H11599

Red, Bold, Italic notes in the Descriptive Report were made during Office

Descriptive Report to Accompany Hydrographic Survey H11599

Project S-E915-BH-NRT7-06
Elizabeth River Demonstration Project
Scale 1:10,000
May-June 2006

Figure 1.1.1

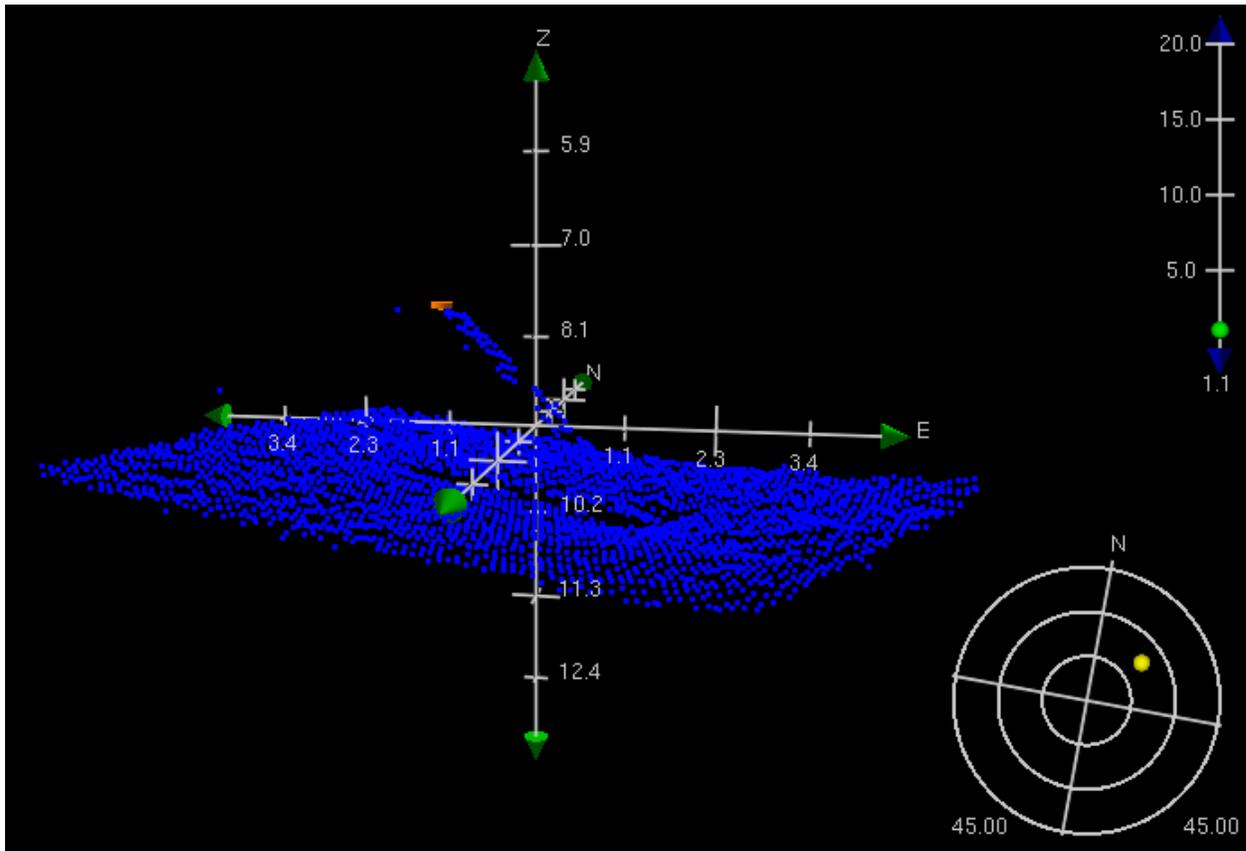
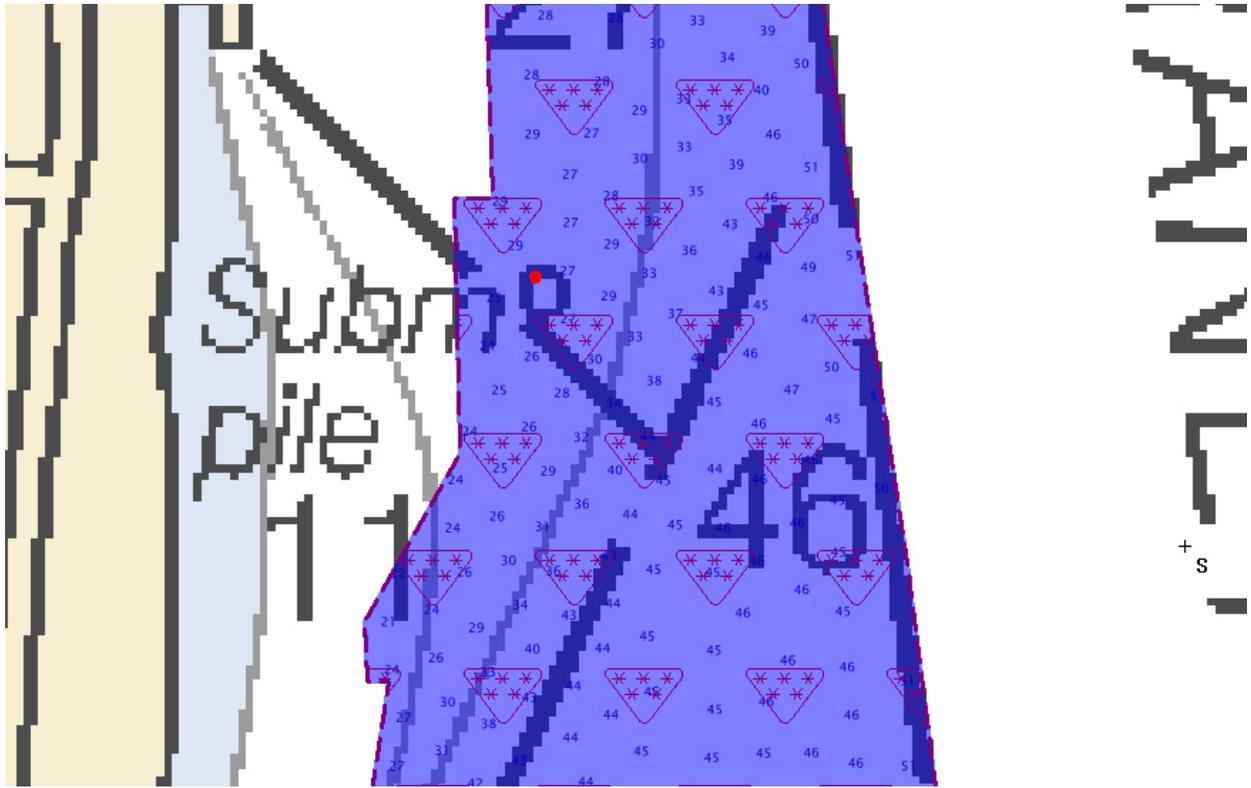
Concur. Submerged Pile is currently charted on the continual maintained raster chart. Retain as charted.

Retain as charted.

Figure 1.4.1

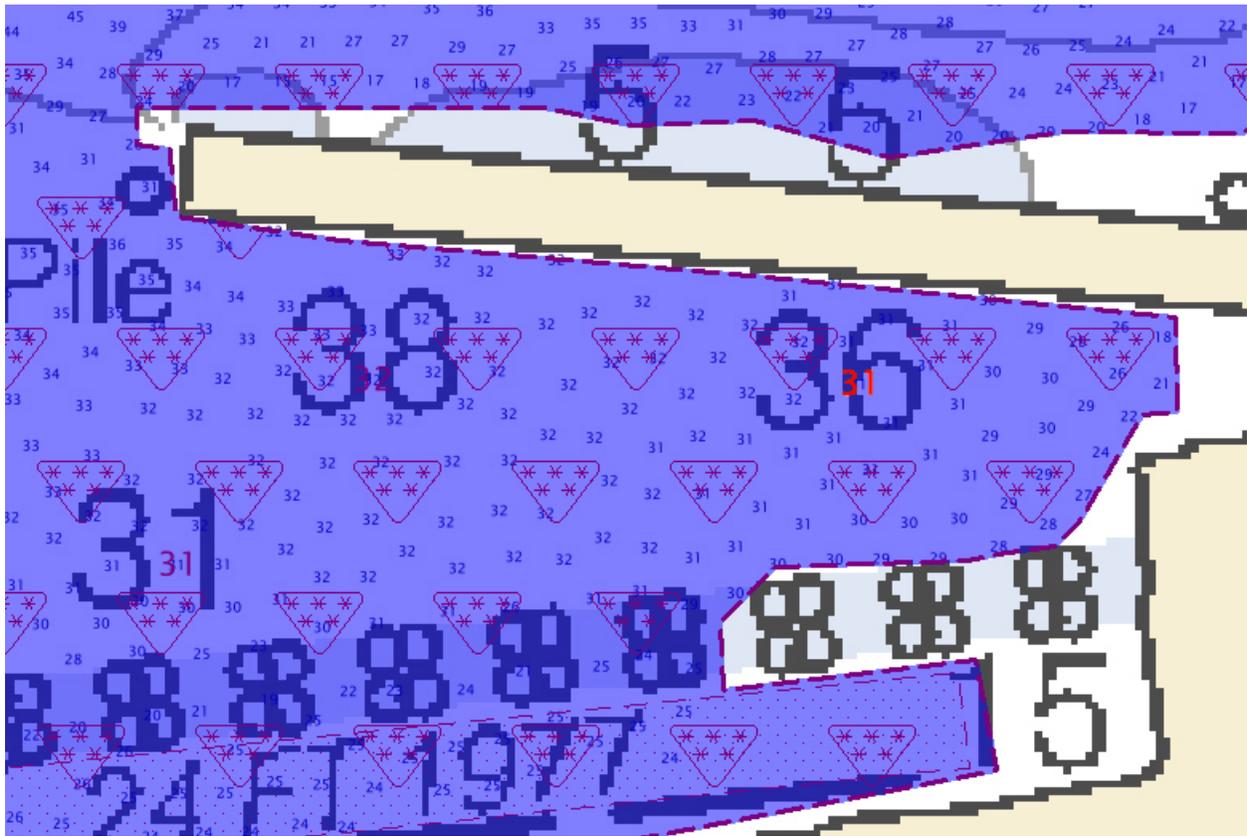
Concur with clarification. Chart 31ft sounding at the surveyed location in Latitude 36°52'38.73"N, Longitude 076°19'41.35"W.

Figure 1.1.1

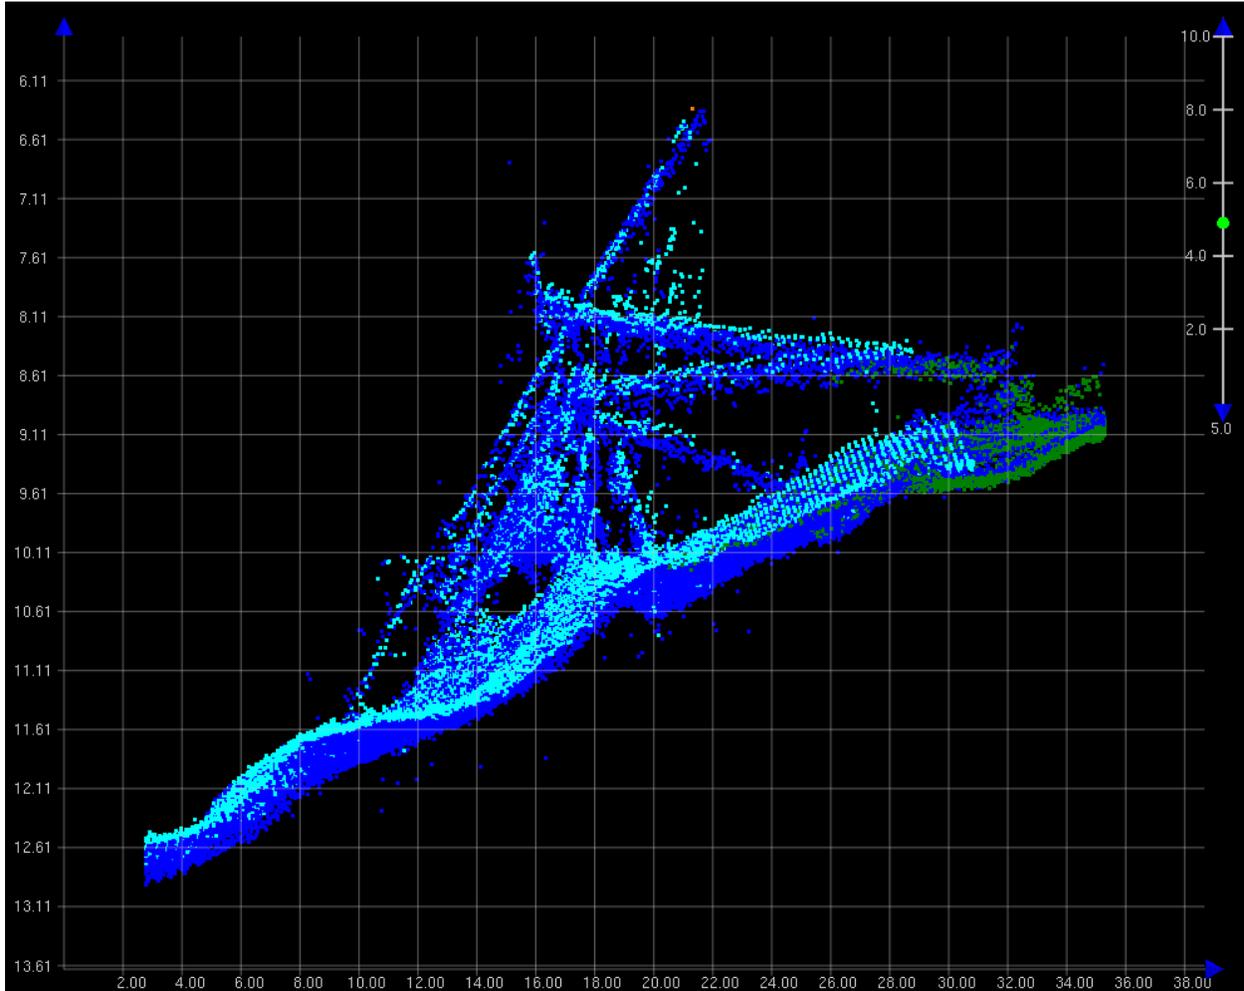
Concur with Clarification. Delete charted OBSTN 15ft LD at latitude 36°51'15.40"N, longitude 076°18'19.70"W.
Chart OBSTN 20ft LD in latitude 36°51'15.117"N, longitude 076°18'19.084"W.

Update least depth on obstruction.

Figure 1.1.1

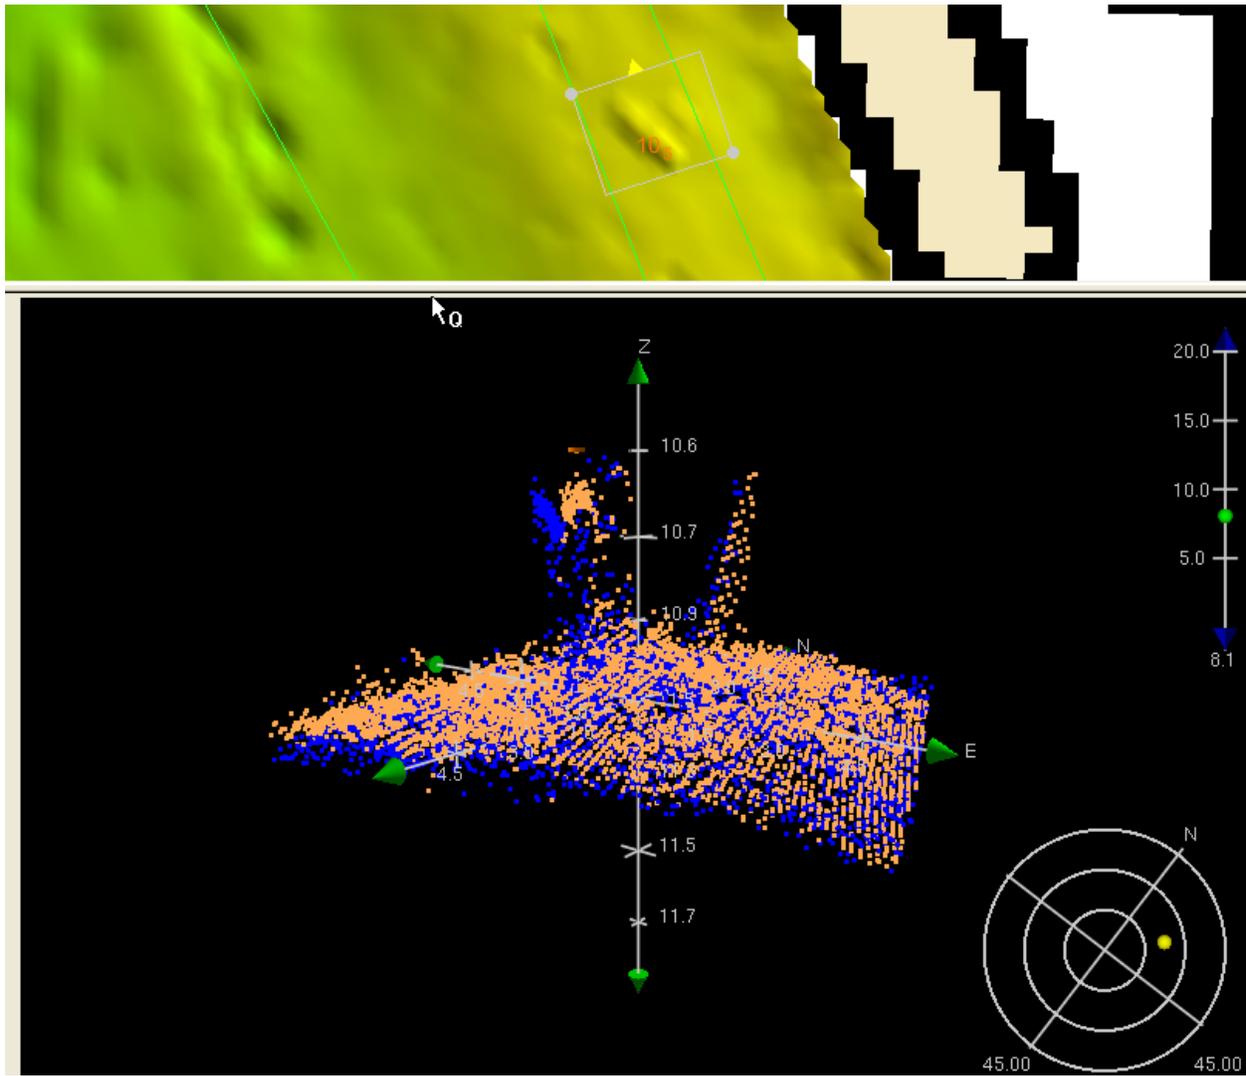
Concur. Chart obstruction least depth 34ft in latitude 36°50'49.861"N, longitude 076°17'47.167"W.

Chart obstruction.

Image 1: Google satellite imagery centered at $36^{\circ}51'48.6''\text{N}$, $076^{\circ}18'44.3''\text{W}$

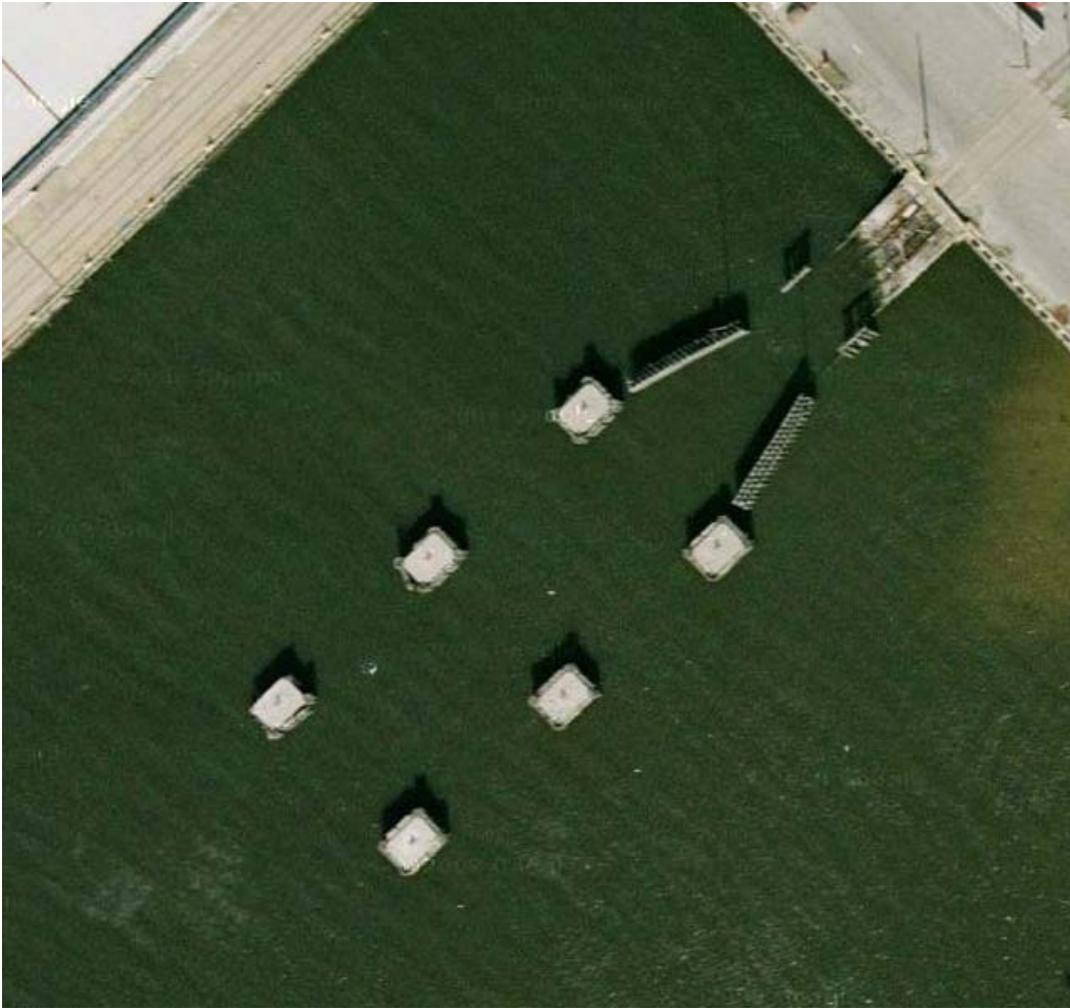
2. Three charted piles in the vicinity of 36° 52’ 50.3”N, 076° 19’ 40.8”W were disproved by 100% MBES coverage, but were not mentioned by the field unit. Recommend deleting piles from ENC US5VA17M. Refer also to the US511599_BlueNotes.000 file. A charting discrepancy exists between chart 12253 and ENC US5VA17M. The piles are located in the ENC US5VA17M, and not portrayed on raster chart 12253. Google map image portrays the MORFAC (dolphin) but does not portray the piles. See Image 1.
